Case Name/ Number: The Enclave at Todd Creek / PRC2025-00002

Development Review Team Comments – 1st Review

Project Name: The Enclave at Todd Creek

SHEET 2 OF 2

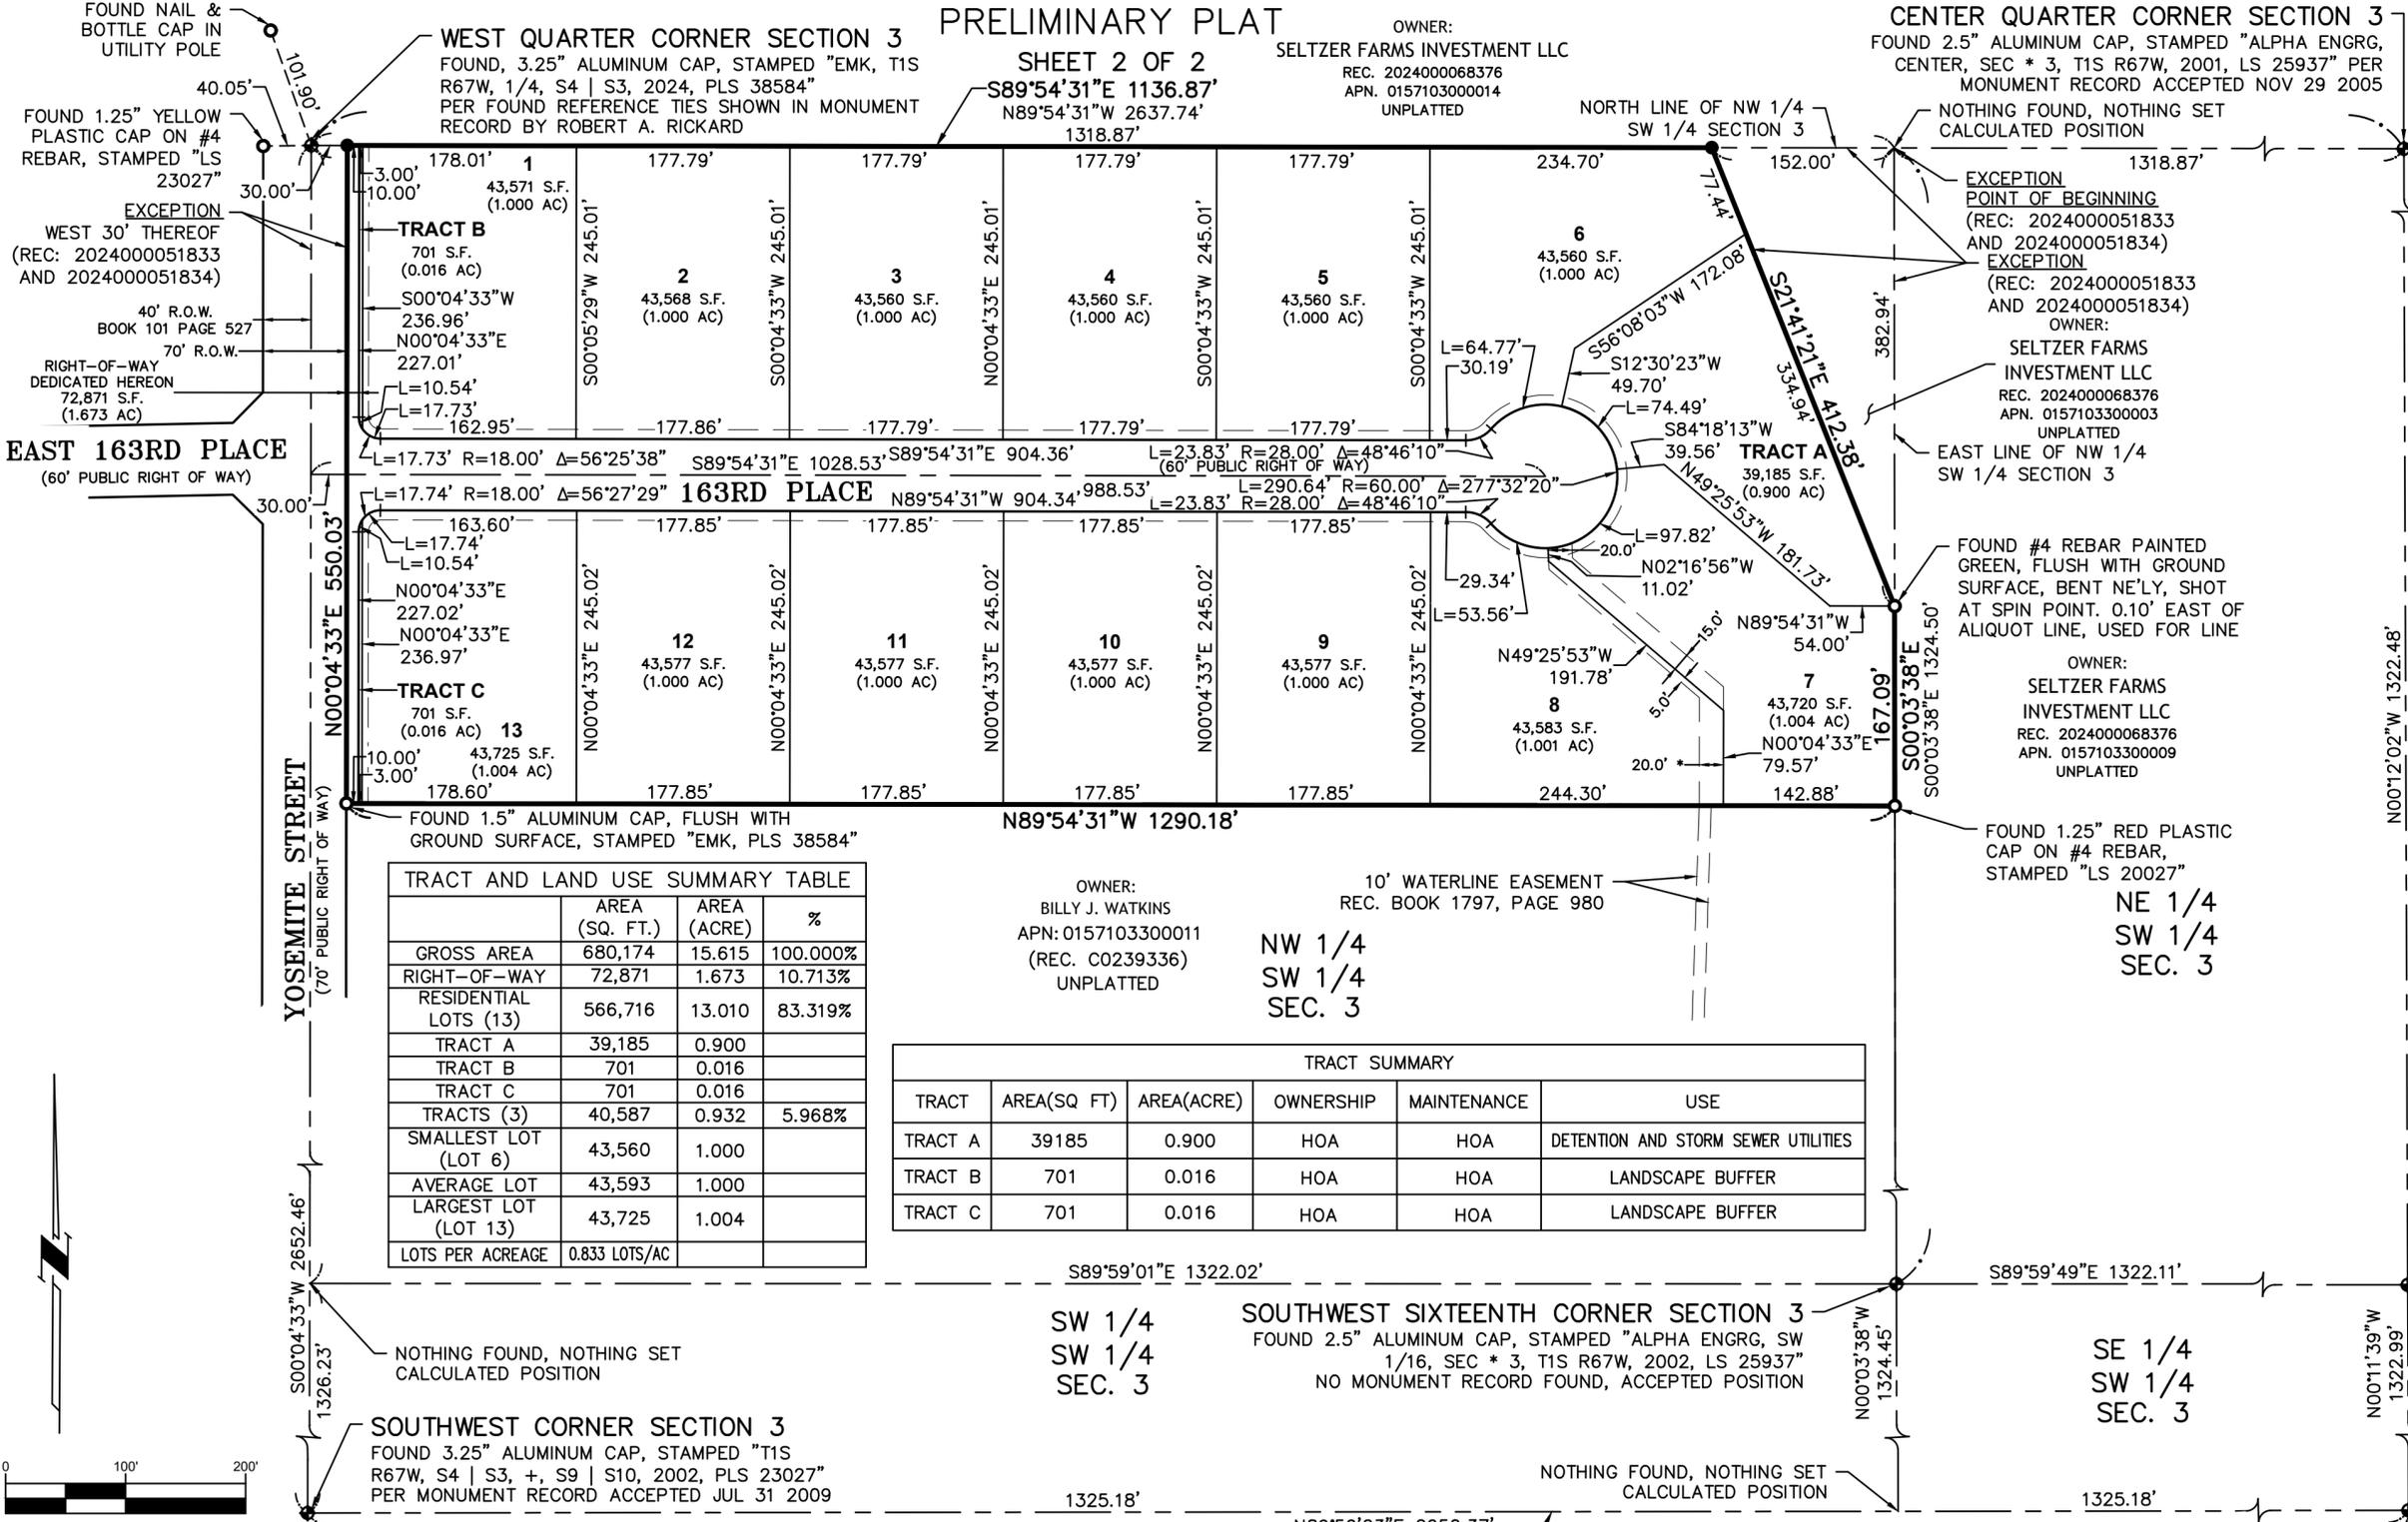
4. Preliminary Plat (Sheet 2 of 2): Label Tract A on the plat.

5. Preliminary Plat (Sheet 2 of 2): Show and label any easement areas.

RESPONSE : Complete

RESPONSE : Complete

THE ENCLAVE AT TODD CREEK
 ADAMS COUNTY, COLORADO
 SITE PLAN
 PREPARED FOR:
 PEAK 3 PROPERTIES, LLC

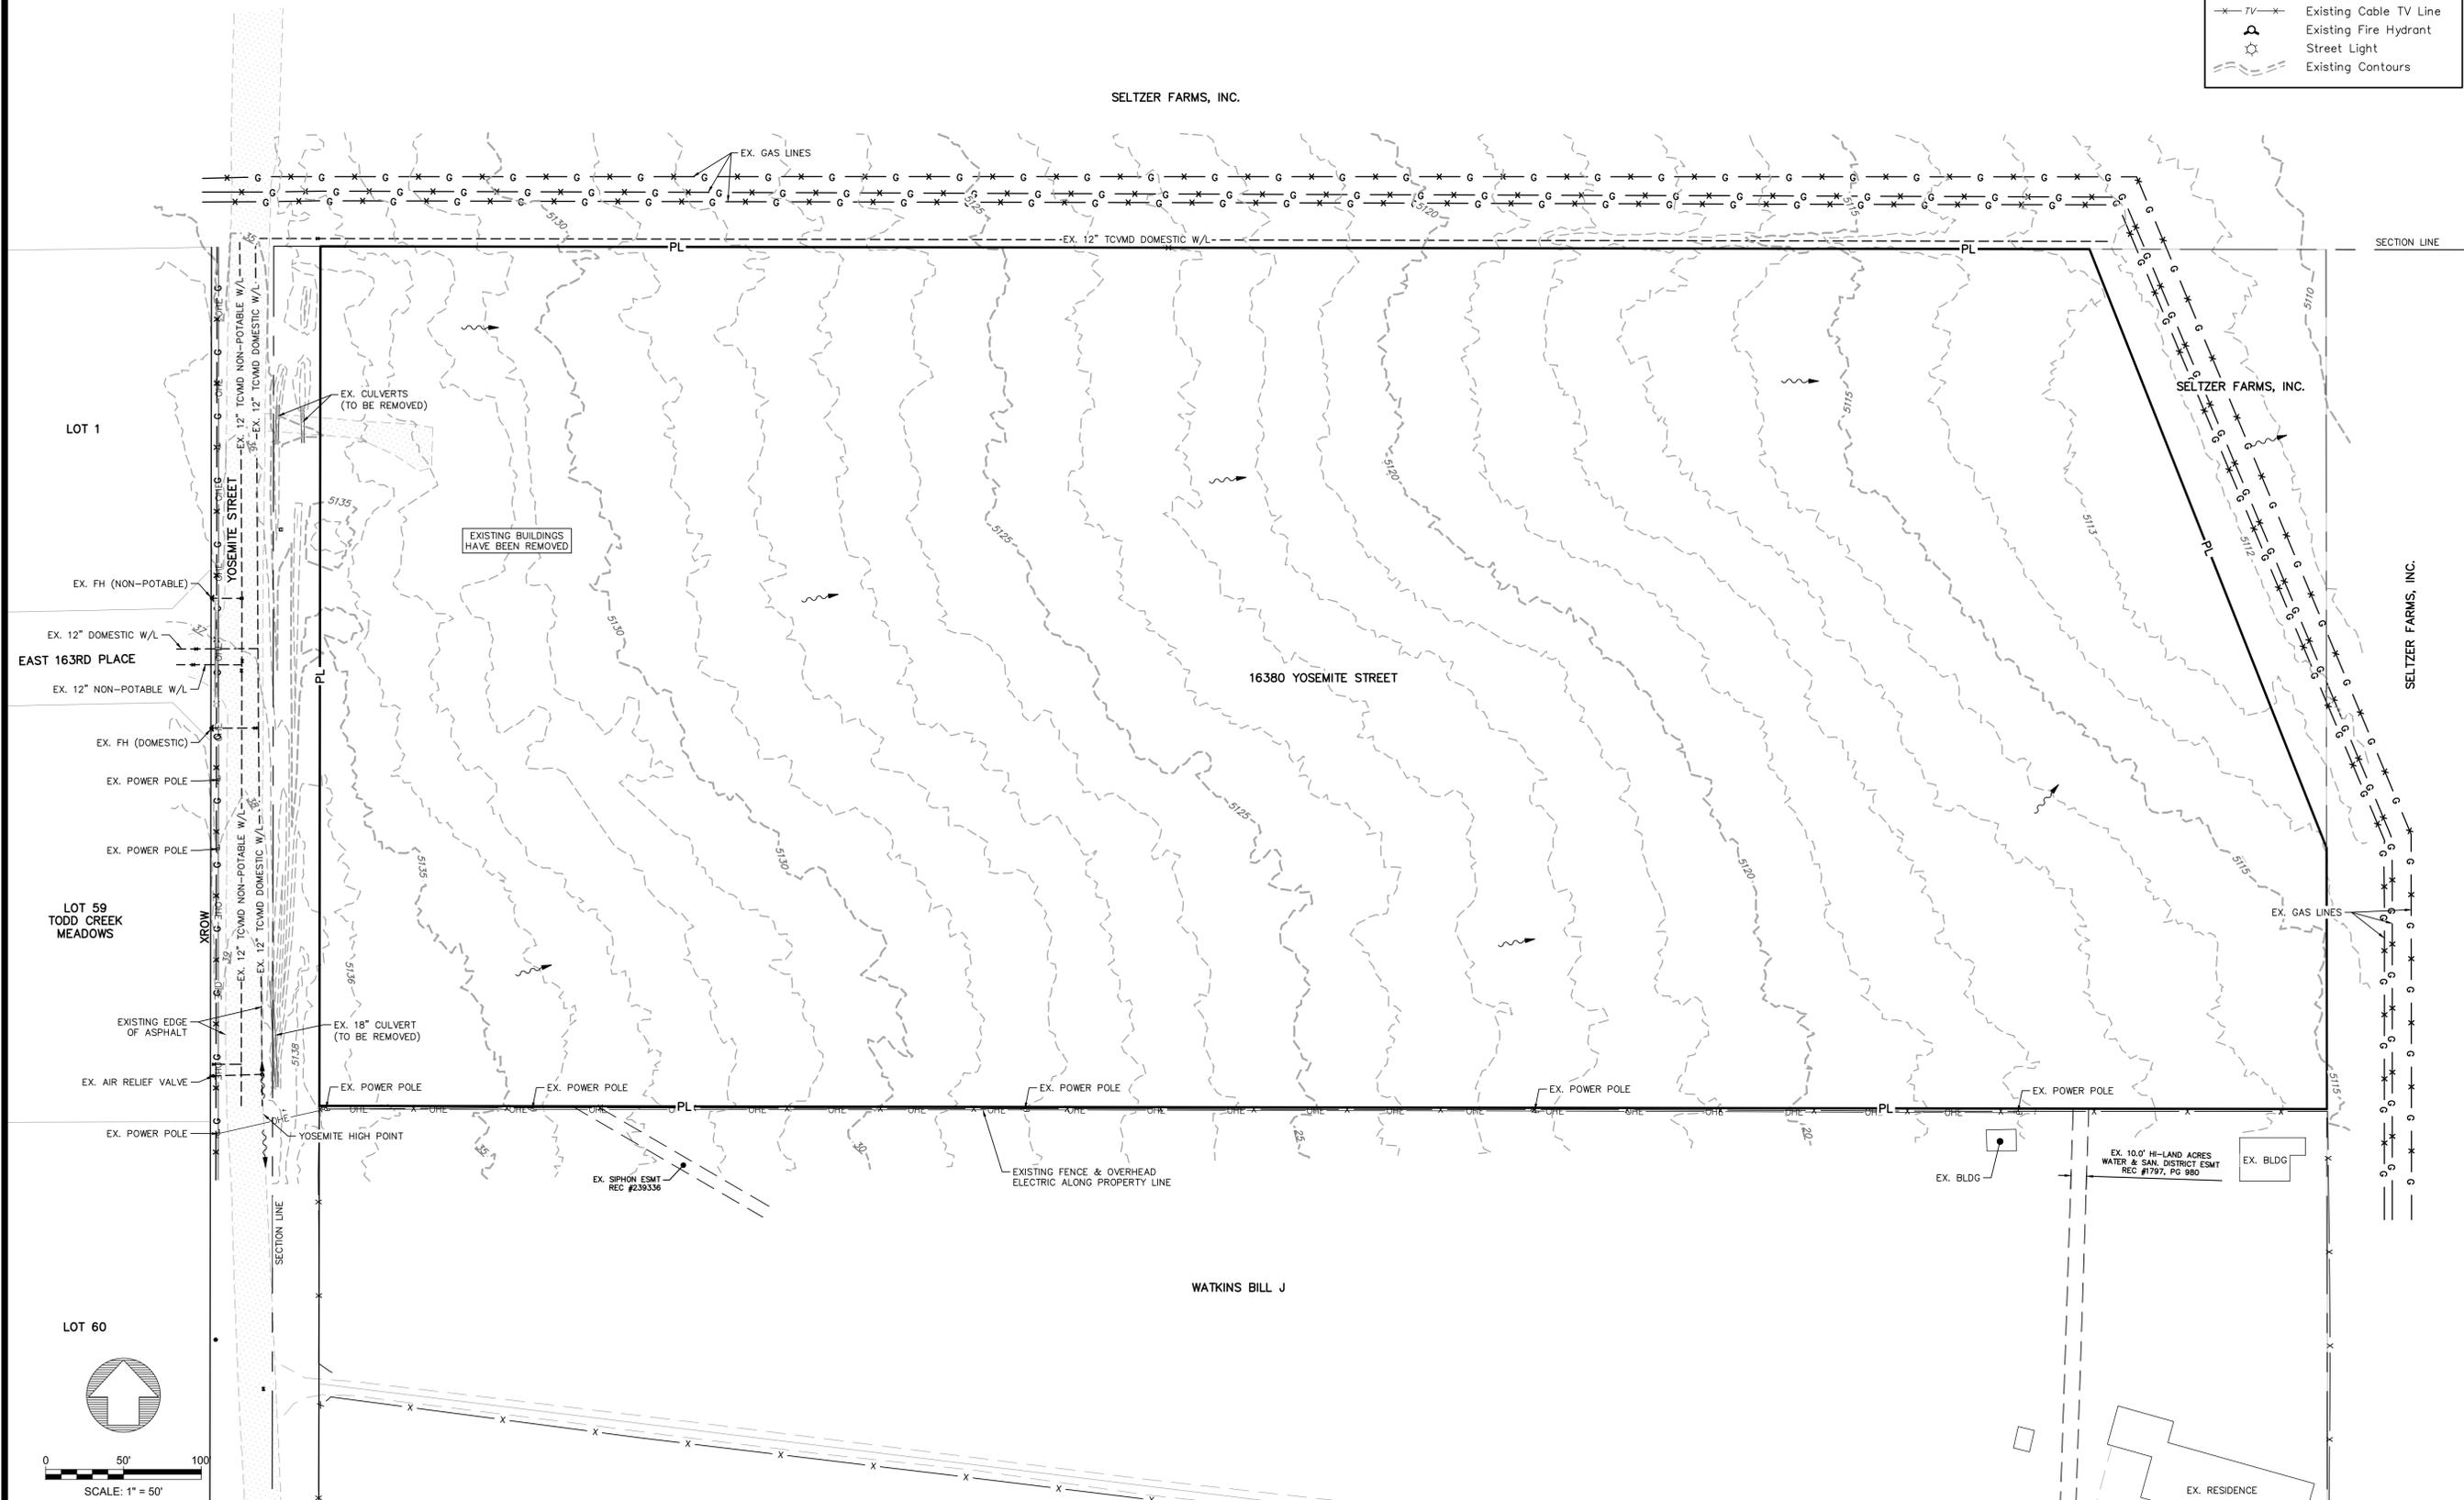
PLN03: As part of the formal proposal, the applicant must submit a site plan demonstrating how all proposed lots, and future homes, comply with county standards.

ENV3. An updated site plan will be required demonstrating locations of site features, existing structures, existing water well, existing septic system components (including piping, tanks, and leach field), proposed structures, and proposed septic system components (including piping, tanks, and leach fields). Please provide linear distances between these items. The individual septic system for each proposed residence, including its leach field, must be contained within the lot boundaries with appropriate setbacks.

RESPONSE : This site plan is included as part of the Construction Drawings.

RESPONSE : A site plan has been included in the preliminary construction plans. The site plan shows the requested proposed items.
